**REVIEW OF FORECAST CAPITAL EXPENDITURE:
SECOND REGULATORY PERIOD**

**La Union Electric Company Inc
(LUECO)**

ADDENDUM

ENERGY REGULATORY COMMISSION

Recommended Capex Adjustments (PhP million, real 2009)

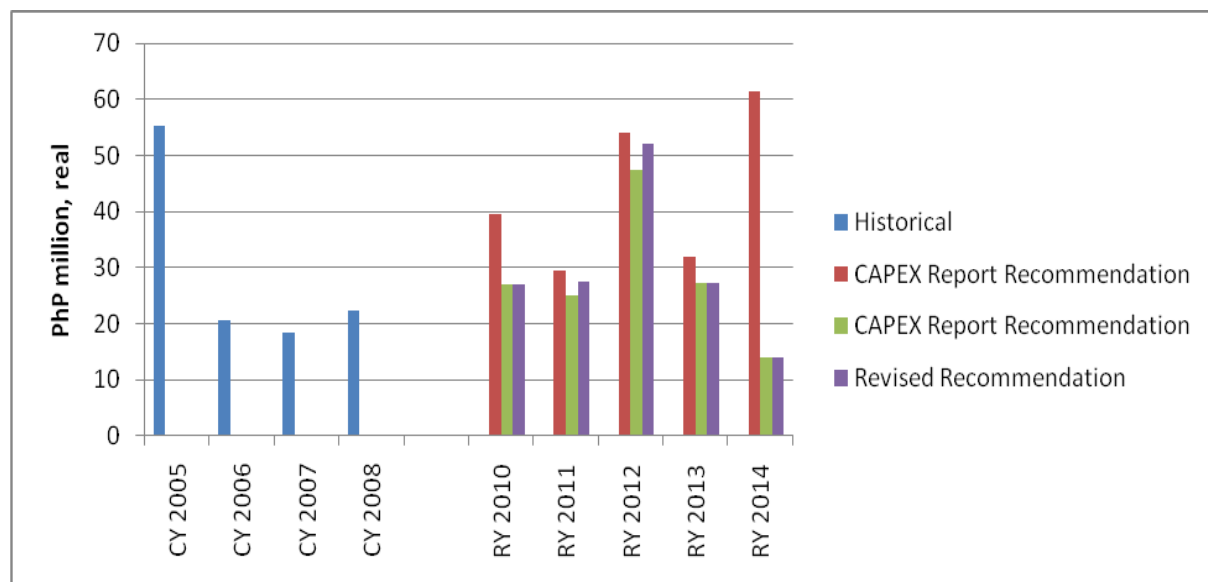
The recommended adjustments allow for an increase in the capacity of the new transformer at Bauang substation to provide a greater level of redundancy in an N-1 contingency situation and to defer the future requirement for additional power transformer capacity. It also provides for the advancement of the construction of the Central Bank line as an insurance against a complete failure of the existing transformer at Bauang.
